**Re: CambridgeSide Third Floor Re-Tenancing Project: Special Permit No. 66:
Request for Amendment**

Re: CambridgeSide Third Floor Re-Tenancing Project

**Cambridge Community
Development Department**
2 JANUARY 2019

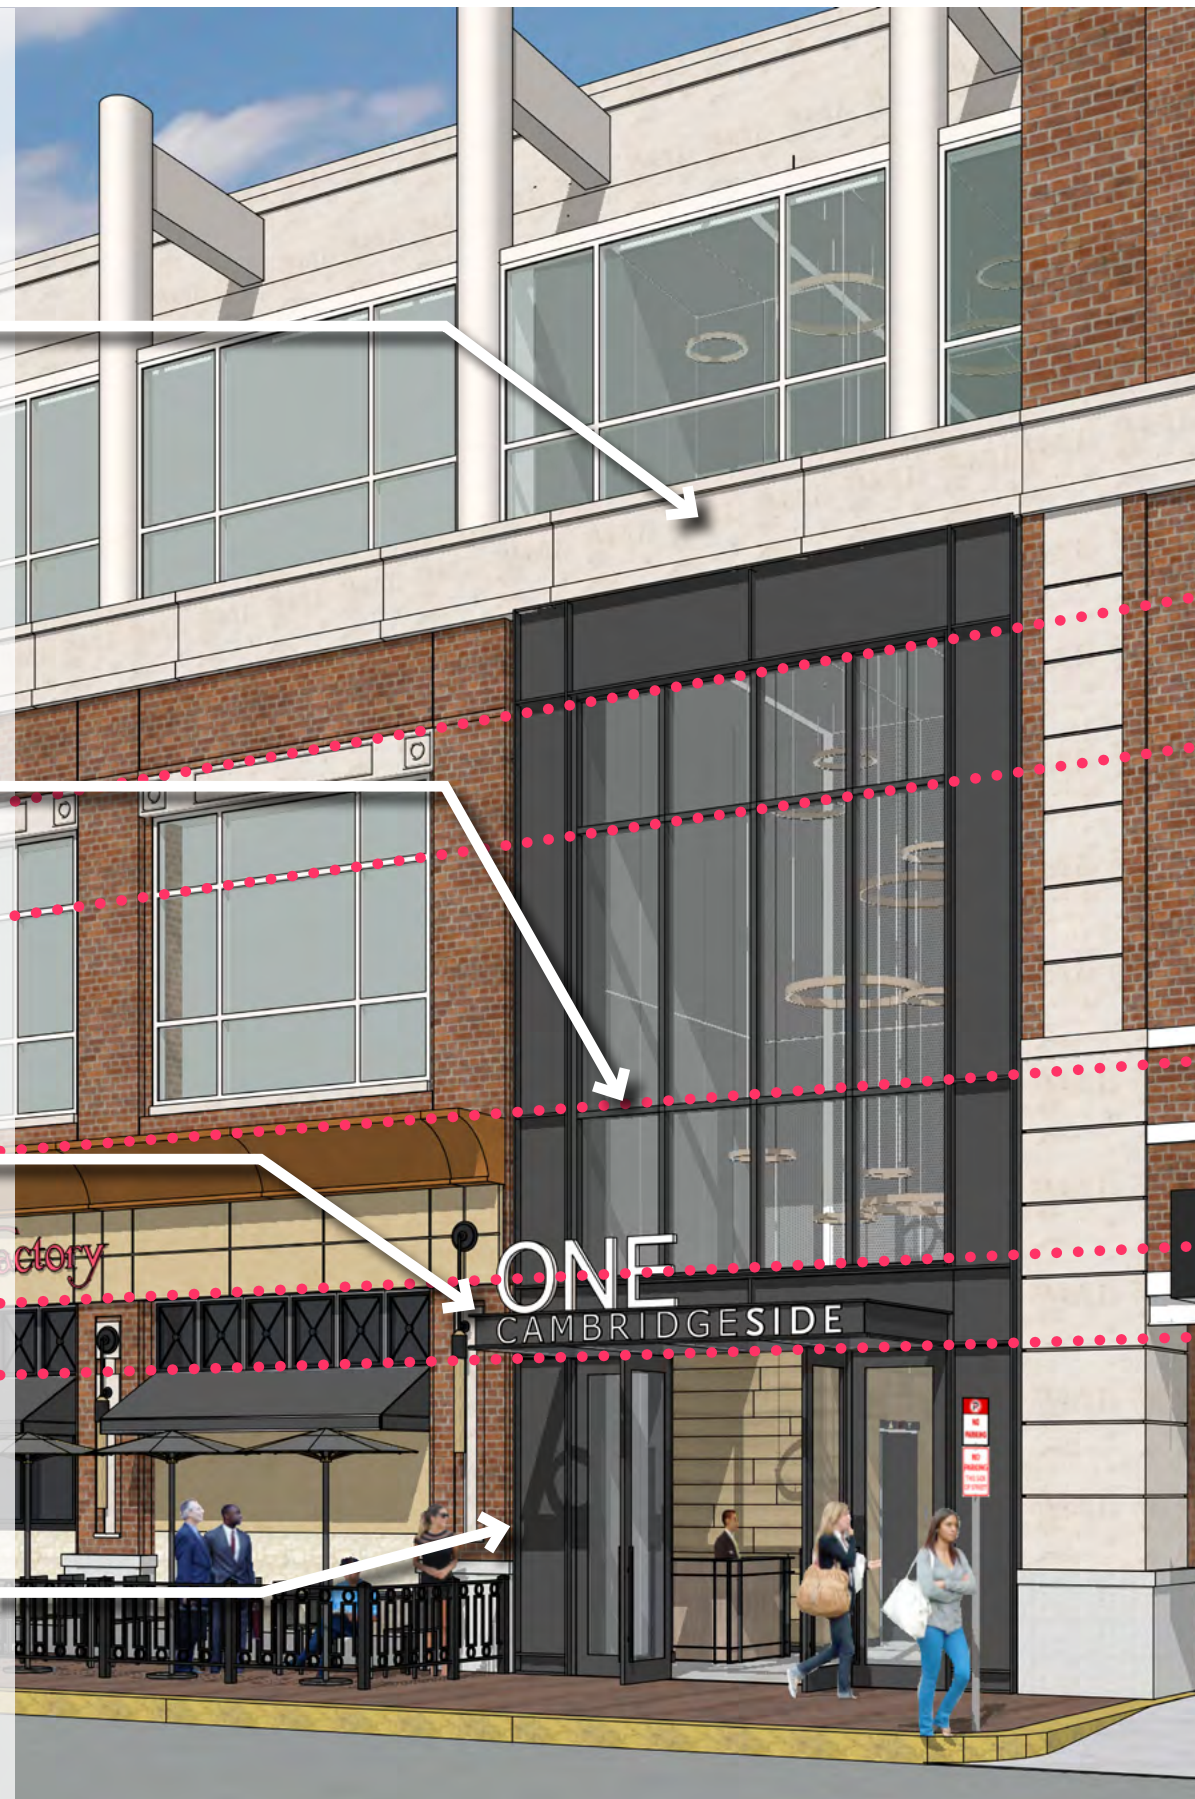
- To ensure that a meaningful streetwall is maintained on Cambridgeside Place, consideration should be given to:
- Creating a more coherent relationship between the bay system of the third floor and that of the second and first floors.
 - Creating a stronger sense that the masonry streetwall façade has a substantial thickness, i.e.: that it is not merely a thin surface plane at the left and right of the double-height lobby.

THE STONE CORNICE
SUPPORTS THE READING
OF A TWO STORY BRICK
BUILDING UPON WHICH THE
THIRD FLOOR BUTTRESSES
APPEAR TO BEAR

DIVIDED LITES PROVIDE
SCALE TO THE LARGE
DISPLAY WINDOWS ON THE
SECOND FLOOR

CANOPIES, AWNINGS, COLOR
AND SIGNAGE IDENTIFY
TENANTS AND PORTALS

BRICK DETAIL WITH INSET
DOOR AND WINDOW
FRAMES SUPPORT READING
OF DEPTH TO THE BRICK
FACADE

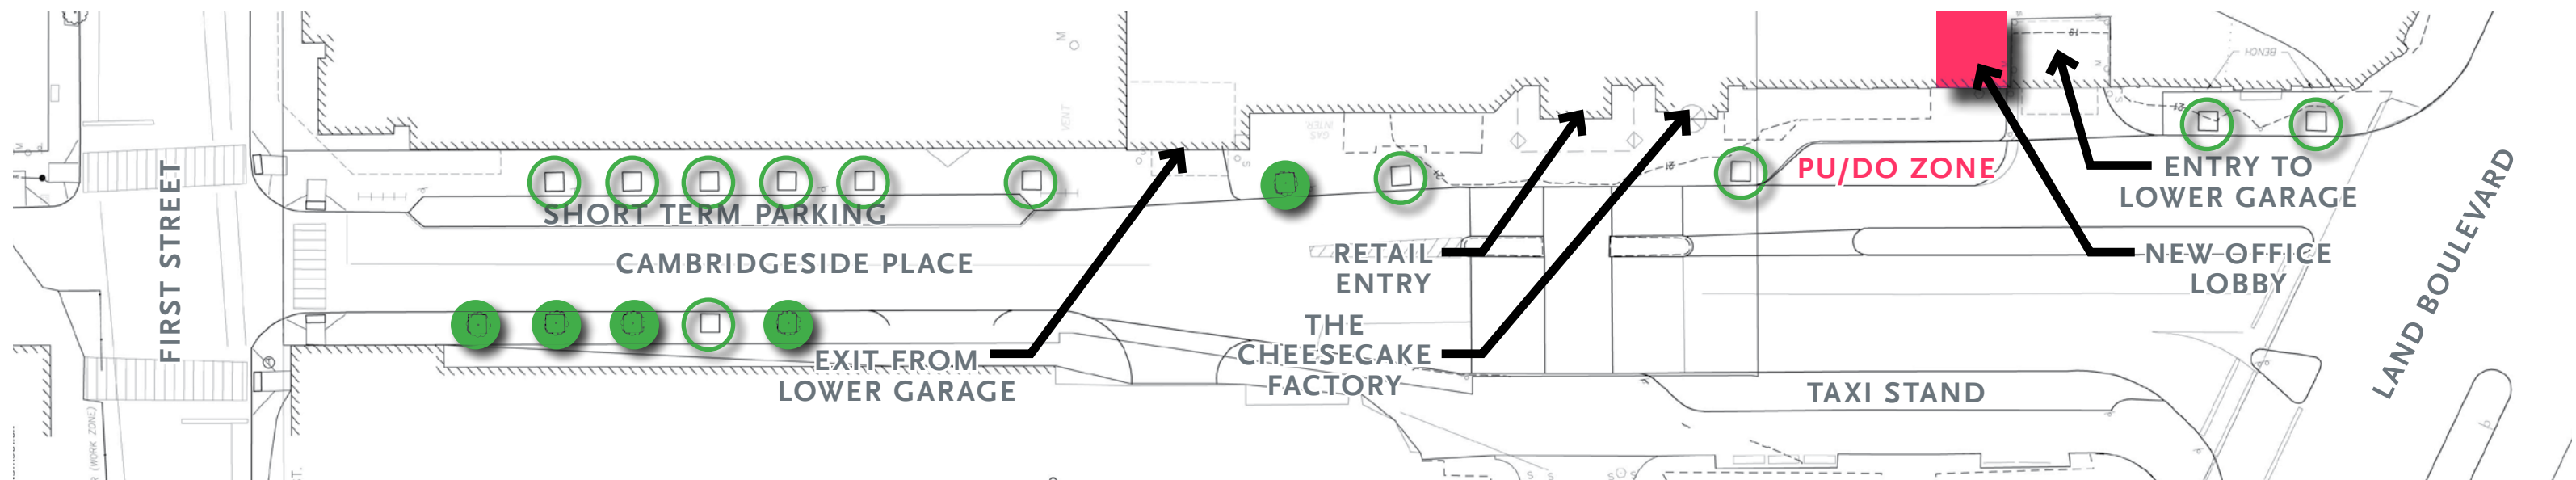
To ensure that a meaningful streetwall is maintained on Cambridgeside Place, consideration should be given to:

- Creating a more coherent relationship between the bay system of the third floor and that of the second and first floors.
- Creating a stronger sense that the masonry streetwall façade has a substantial thickness, i.e.: that it is not merely a thin surface plane at the left and right of the double-height lobby.

In addition, consideration could be given to:

- Eliminating what appears to be spandrel glass at the left and right sides and top of the new curtainwall façade zone.
- Studying different treatments of the glazed area, potentially including sun shading.

In addition, consideration could be given to:

- Improving the paved pedestrian area and the vehicular drop off area in response to the new lobby, including planting new canopy trees to replace the potted plants currently at the edge of the sidewalk and in the raised median between the pull-off lane and the street.

BY RETAINING THE STONE CORNICE, THE NEW ARCHITECTURAL FRAME IS INSERTED INTO THE TWO STORY BRICK BUILDING, CONSISTENT WITH THE SCALE AND PROPORTION OF ADJACENT RETAIL TENANTS

REGULATING LINES INFORM THE TWO STORY DISPLAY WINDOW, INTEGRATING IT INTO THE EXISTING FACADE

A NEW CANOPY, BLACK METAL FRAME AND CONTRASTING SIGNAGE IDENTIFY THE NEW OFFICE LOBBY

BRICK DETAIL WITH INSET FRAME MAINTAINS THE EXISTING RELATIONSHIP OF BRICK TO FRAME TO OPENING

ENHANCE LANDSCAPING WHERE POSSIBLE. THE LOWER GARAGE PROJECTS UNDER THE SIDEWALK IN THIS AREA, LIMITING PLANTING OPPORTUNITIES.

REPURPOSE DEDICATED CHEESECAKE FACTORY PICK-UP ZONE (3 SPACES) TO PICK-UP AND DROP OFF FOR THE NEW OFFICE LOBBY
